TRANS/WP.29/GRE/2004/16  
19 January 2004

PROPOSAL FOR DRAFT AMENDMENTS TO REGULATION No. 37  
(Filament lamps)

Transmitted by the expert from the Working Party "Brussels 1952" (GTB)

## CATEGORIES H13 AND H13A

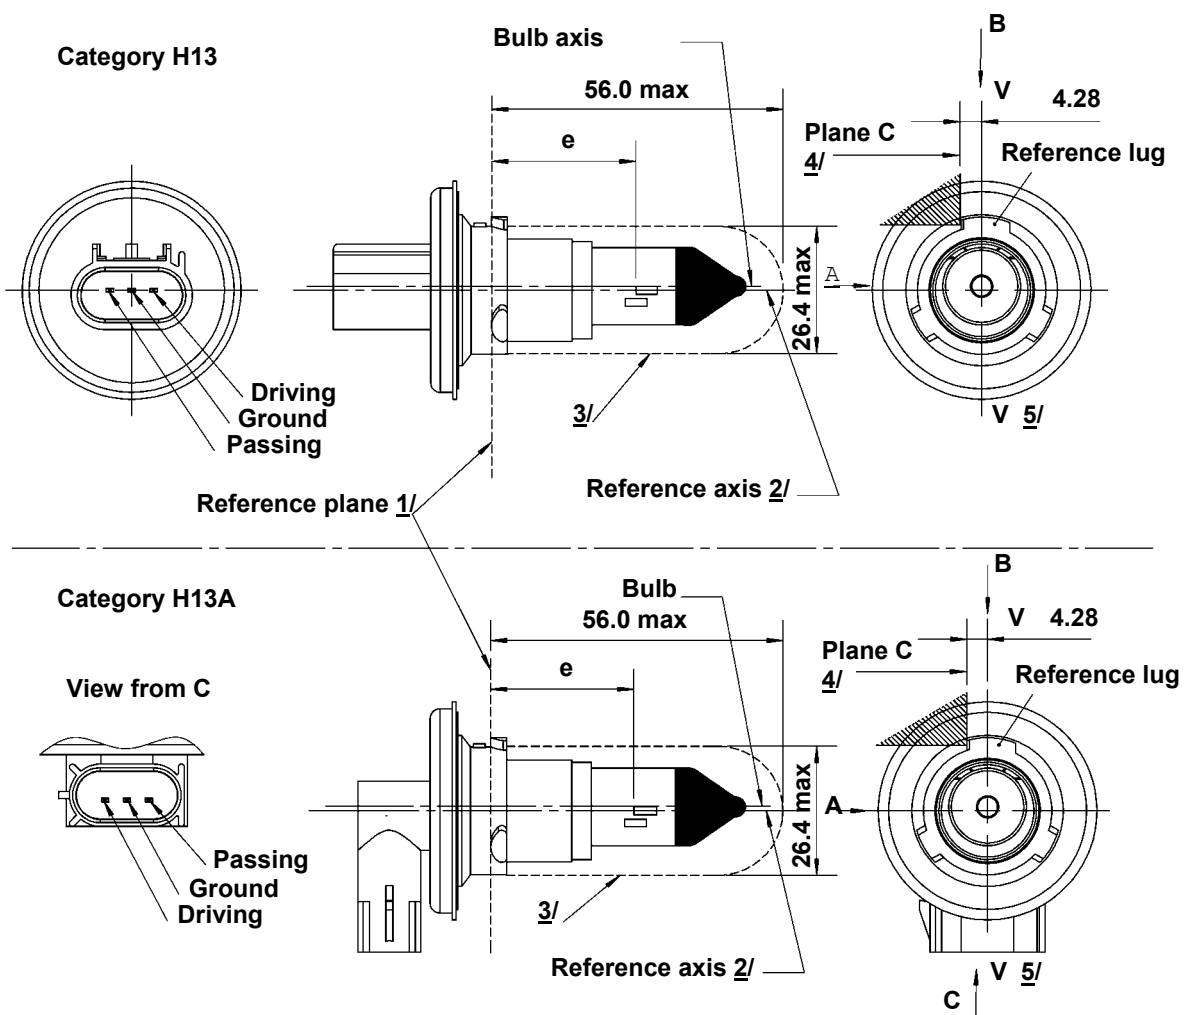
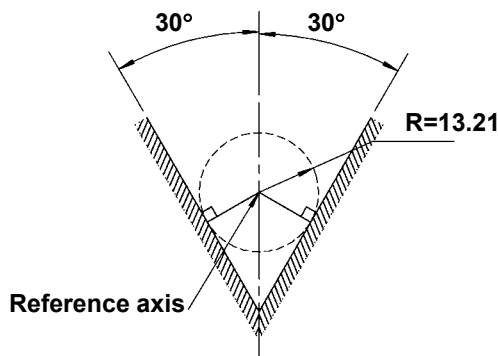
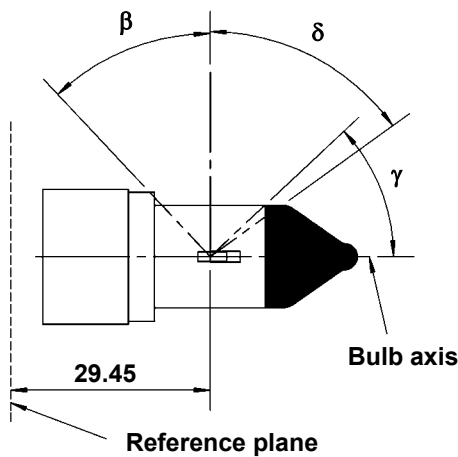
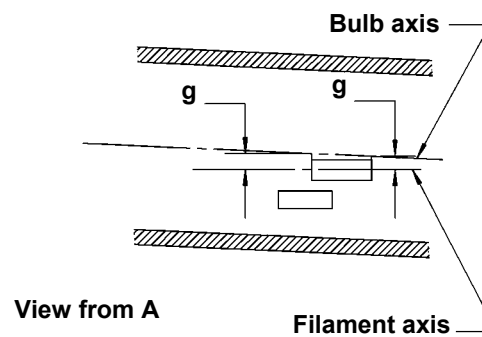
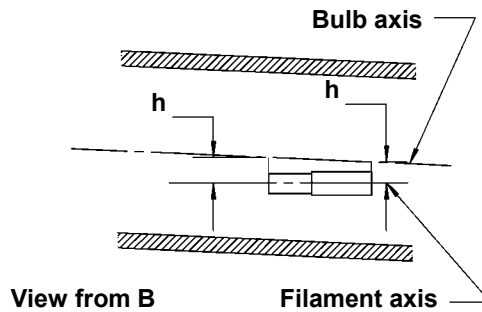
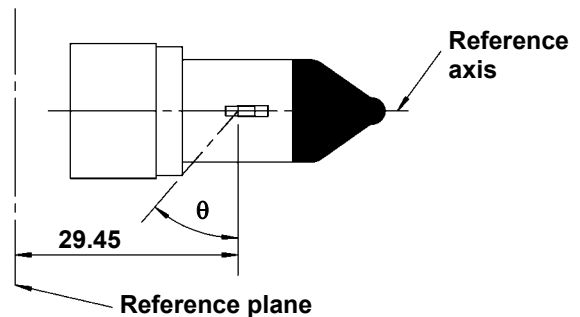
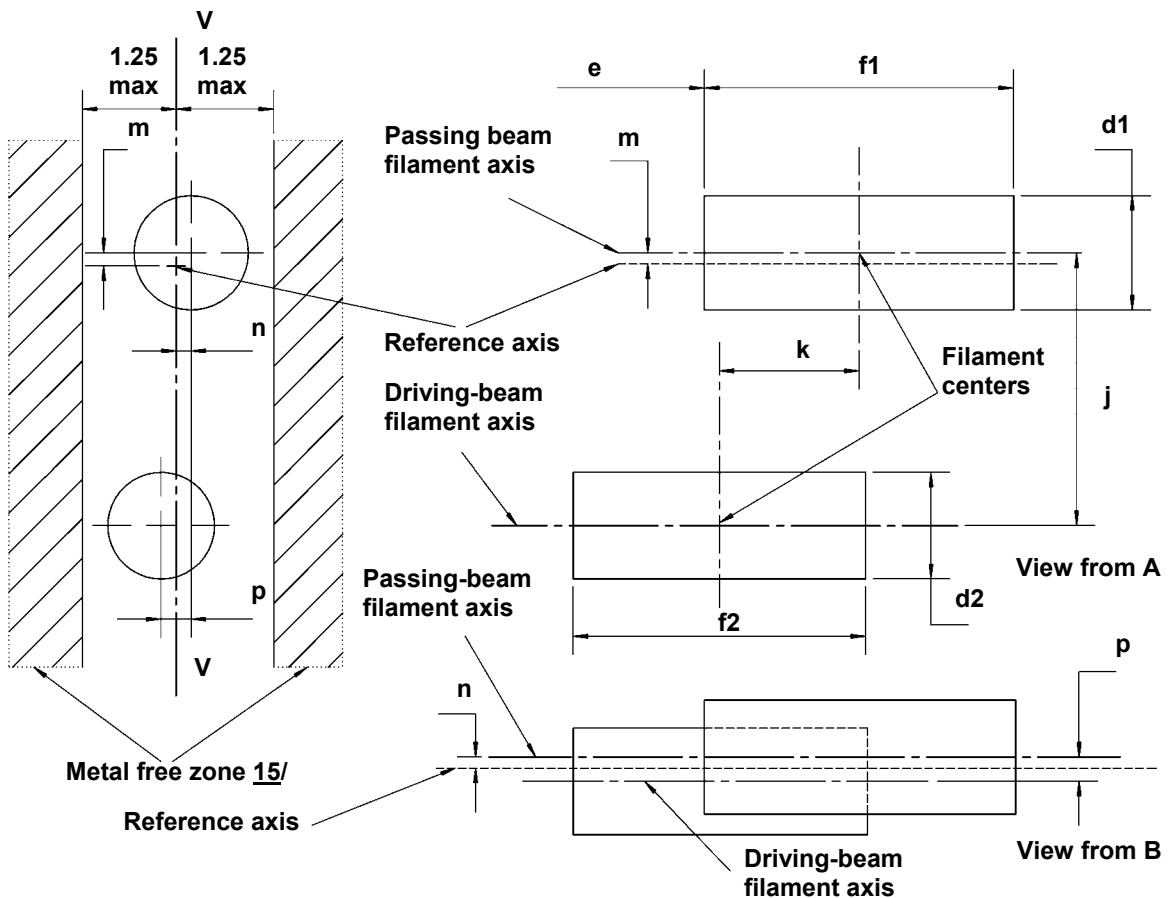
Sheets H13/1 to 4, replace by new sheets H13/1 to 4; (see next pages).

### 4. Amendments H13 and H13A.

This proposal is made to maintain the specifications of H13 and H13A "harmonised" to those that are filed in the United States of America's NHTSA docket system.

**CATEGORY P13W**

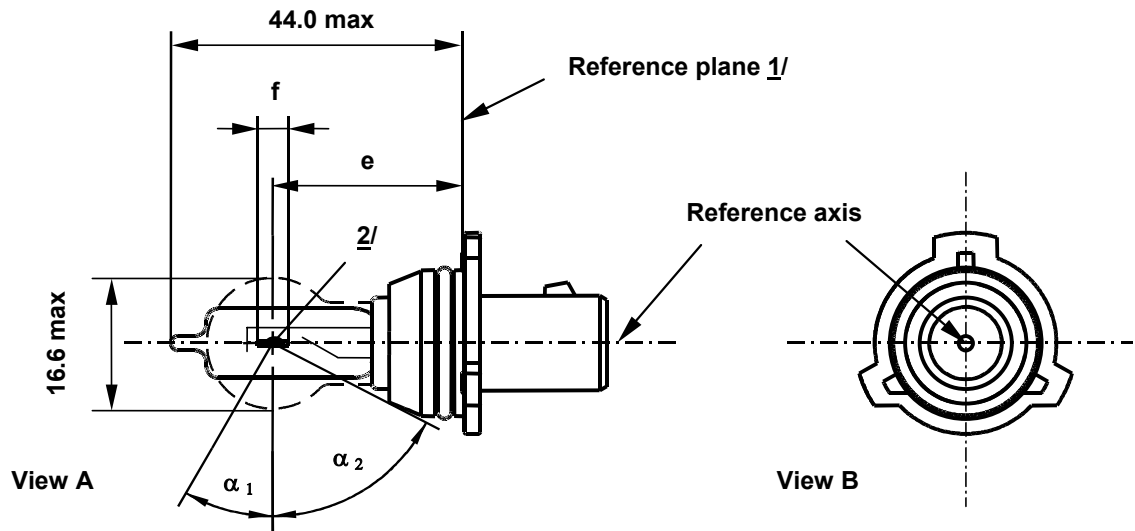
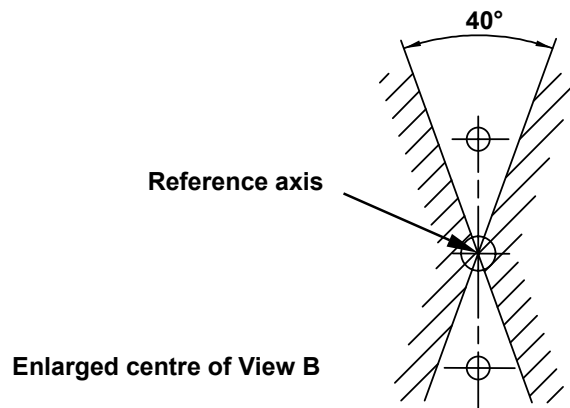
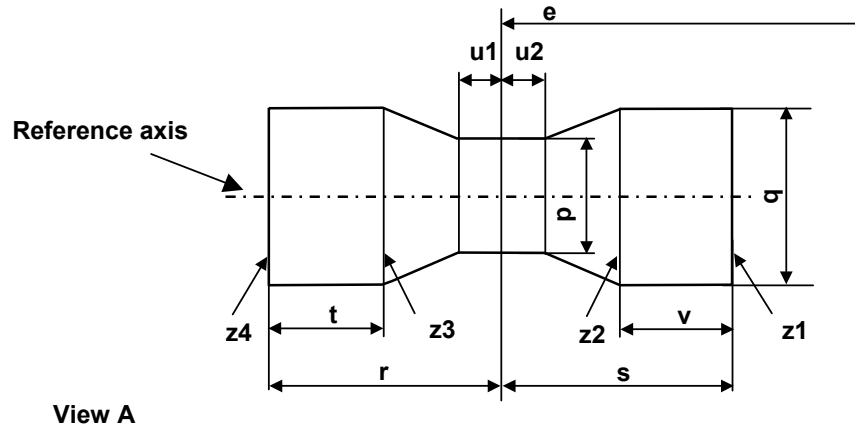
Insert new sheets P13W/1 to 3 (between sheet HS5/4 and sheet P19W/1 as indicated in the "List of sheets" above), to read: (see next pages).

### 1. Introduction of P13W

In view of the increased attention to Daytime Running Lights, a new filament light source was designed for use in Regulation No. 87 lamps. Characteristics of these light sources were significantly improved as compared to existing filament light sources because of their lower power consumption, their very high lifetime, which is car life designed, and their high precision dimensions, which make them suitable for all kinds of lamp reflectors.

5. Proposed amendments to Regulation No. 87 photometric requirements. Parallel to the proposal for introduction of the filament light source P13W, GTB also proposes amendments to the photometric requirements as specified by Regulation No. 87. This has consequences for the P13W specifications. Those parameter values that needed to be balanced again were put between square brackets [...] in this document, although approved by GTB. The earlier specifications, also approved by GTB, but tuned at the current Regulation No. 87 photometric requirements were as follows:

- Sheet P13W/2:

f	<u>5/</u>	3.9	<u>4/</u>	$3.9 \pm 0.2$
---	-----------	-----	-----------	---------------

Objective values	Wattage	W	18 max.	18 max.
	Luminous flux	lm	200	
		±	15%	
Reference luminous flux at approximately 13.5V				200 lm

- Sheet P13W/3:

p	q	u1,u2	r,s	t,v
Filament lamps of normal production	1.7	1.9	0.3	2.4	0.9
Standard filament lamps	1.5	1.7	0.25	2.25	0.6
